# SCHWEIZER SERVICE BULLETIN

C1B-031  
24 Aug 2010

**SUBJECT:** INCORRECT BUSHING USED IN 269C-1 FLIGHT CONTROLS

**MODELS AFFECTED:** • All 269C-1 Model Helicopters

Figure C1B-031-1. Flight Control Inspection Points

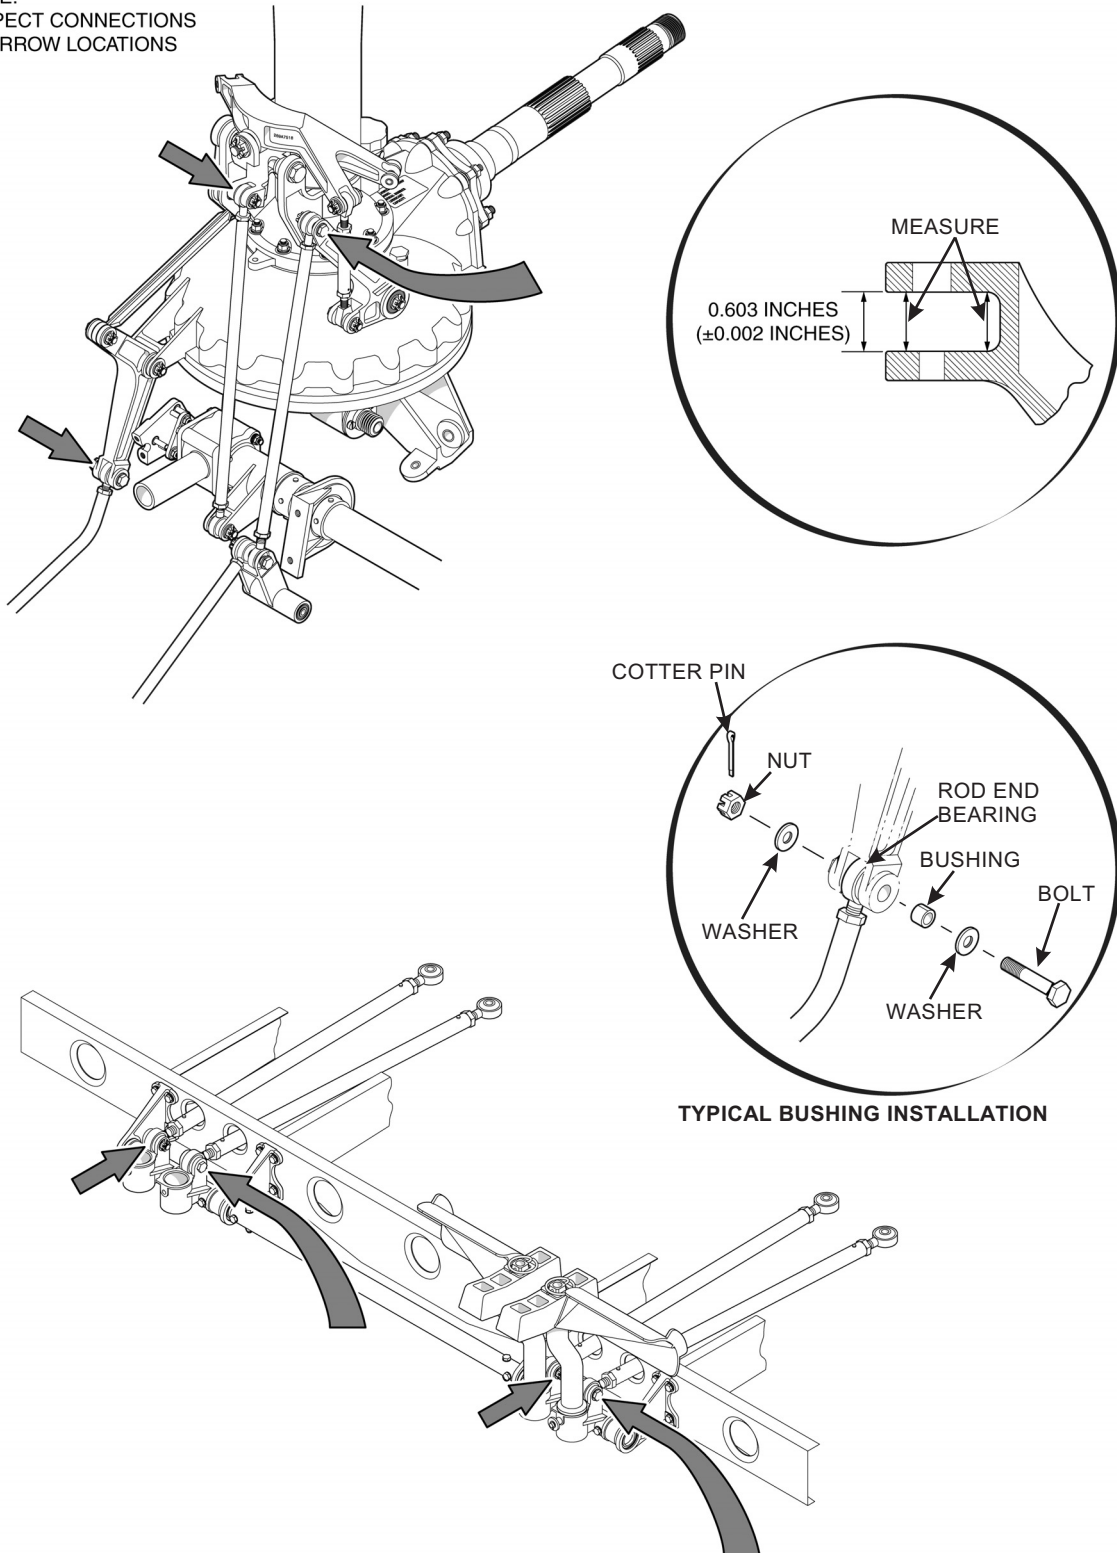
- a. Review Figure C1B-031-1 and note locations of all SHS626-4-313 bushing installations.

At installation, the SHS626-4-313 bushings are designed to be longer than the thickness of the bellcrank lug. When torqued, the bushing should contact the bearing rod end and extend above the bellcrank outside surface, keeping the washer from touching the bellcrank. If the washers on both sides of the fork are in contact with the fork, the incorrect bushing is installed.

- b. Gain access to all flight control rod connections containing SHS626-4-313 bushings and using a bright light and as required a mirror, inspect assemblies for installation of correct length slotted bushing.

**If the incorrect bushing has been installed when the hardware is torqued, the legs of the forks will be drawn to the inner race of the rod end bearing. This can cause permanent distortion of the fork legs that can lead to cracks at the root end of the legs.**

- c. If incorrect bushing is installed, remove bellcrank. Using Vernier calipers, check that the inside surfaces of the fork legs in two locations measure  $.603 \pm .002$  (Figure C1B-031-1) and are parallel to each other. If surfaces are parallel, perform a dye penetrant inspection in accordance with Basic HMI Section 2. Remove from service and destroy any bellcrank found to have distorted or cracked legs.

NOTE:  
INSPECT CONNECTIONS  
AT ARROW LOCATIONS

- d. If a dye penetrant inspection has been performed and the bellcrank is found to be acceptable within the design specifications specified in drawing number 269A7508, restore paint finish in accordance with HMI Appendix D, Corrosion Control Manual.

- e. Reinstall any removed flight control assemblies in accordance with appropriate paragraphs of Basic HMI Section 8 and reinstall fairings, panels and interior assemblies in accordance with appropriate Sections of Basic HMI.
